PARISH OF ST HELIER

## **ROADS COMMITTEE MEETING**

## Roads Committee Report

P/2025/0144 Coppelia and Fieldings,  
Le Mont Pinel – Planning Application  
Page 1 of 4

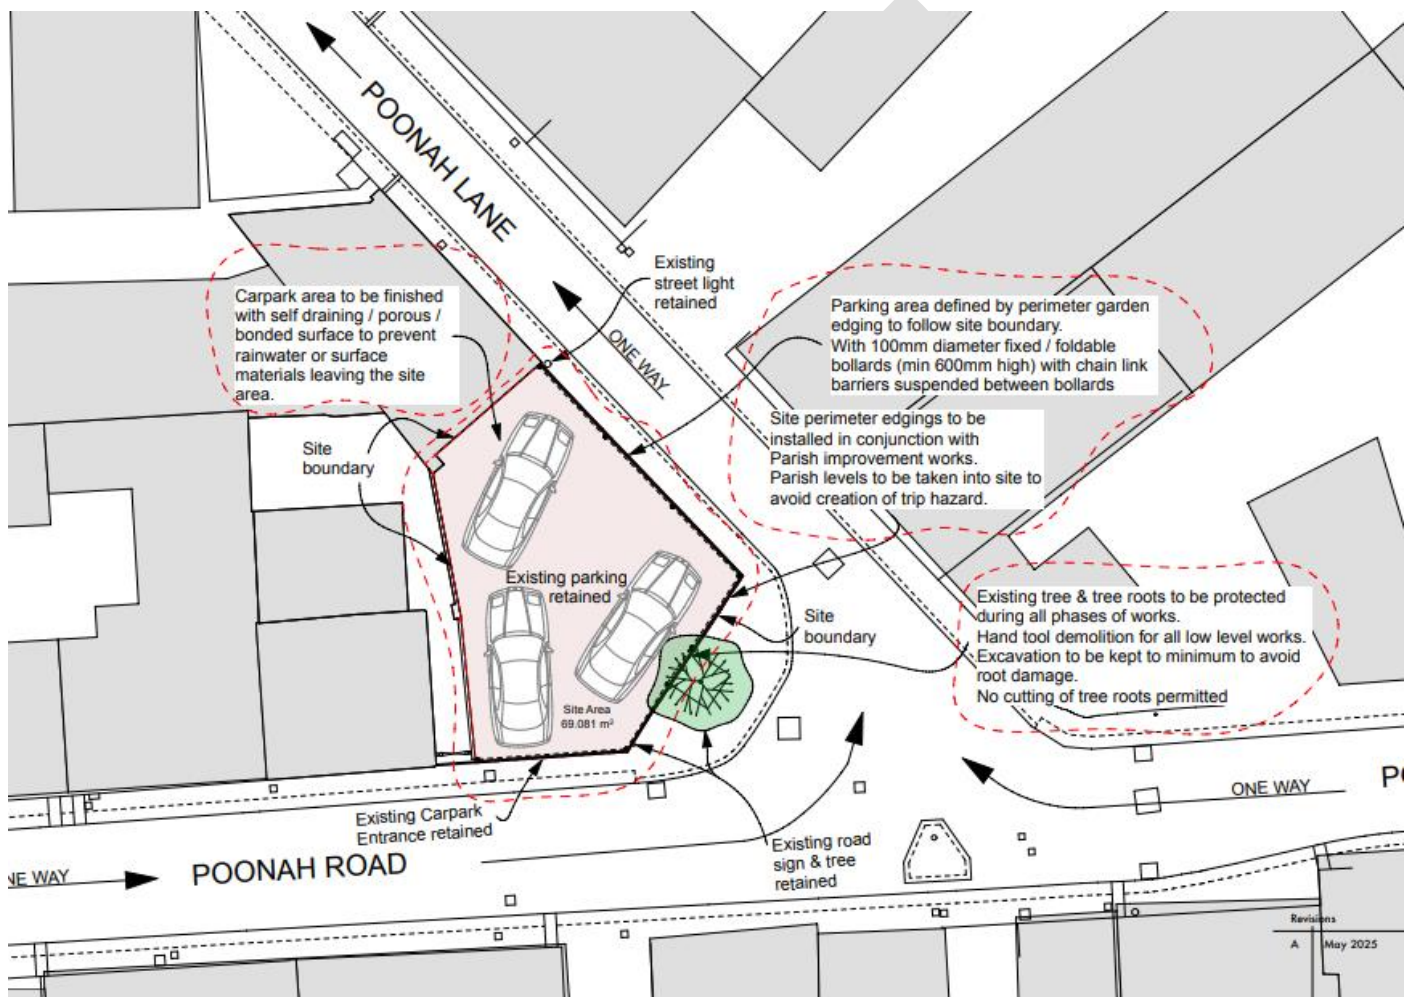
- The refuse store is fitted with a standard Parish lock.

**6. Vacant Site/Carpark, Poonah Road / Poonah lane, St. Helier, JE2 3XP P/2025/0185**  
*Demolish 2 No. roadside walls to Poonah Road & Poonah Lane & Install new bollards with chain link barriers to perimeter of parking area.*

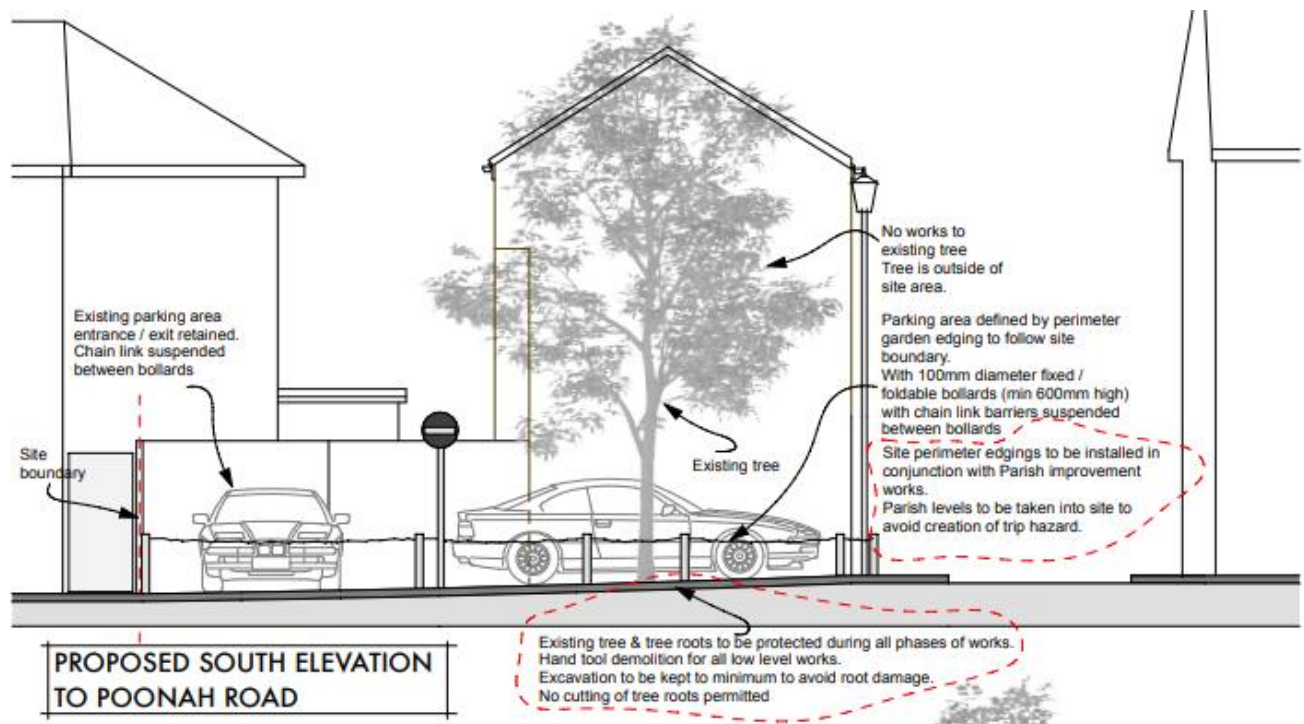
The Roads Committee amends their previous comments following the Parish officer meeting with the Planning Officer and the applicant on site, and confirmation from the applicant that the concerns raised by the Roads Committee are being addressed. The applicant advises that the tree roots will be protected, and that the car parking existing loose material surface will be replaced with a permeable hard surfacing that will result in no loose stone or gravel material being used. This has been confirmed in the revised drawings, extract below:

It is noted that the proposal is to demolish two boundary walls as the applicant advises of the anti-social behaviour and issues that they have experienced with litter issues and sitting on the wall. Presently, the site access/exit is from Poonah Road, and this arrangement will be retained.

1. The applicant is to note that the existing tree on the Parish footway must be protected from the works and safeguard the tree roots as was discussed on site with the Planning Officer and Applicant. This should be conditioned if approval is given.
2. The Roads Committee does not agree to the removal of the wall as it feels that it has a detrimental impact on the aesthetics of the streetscape; however, understands that the decision will be for the Planning department to determine. The applicant has provided the below extract of the elevation.

3. All surface water generated on the existing parking area is to be disposed of within the site by soakaway or other appropriate means such as permeable surfacing.
5. The applicant confirms that there will be a delineation between the Parish footway and the applicant's site, with a line of 50mm wide split blocks shall be laid flush at the junction between the private land and the rear of the public footway for the width of the site. This work will be programmed with the Parish NIA project, subject to the applicant obtaining Planning consent.
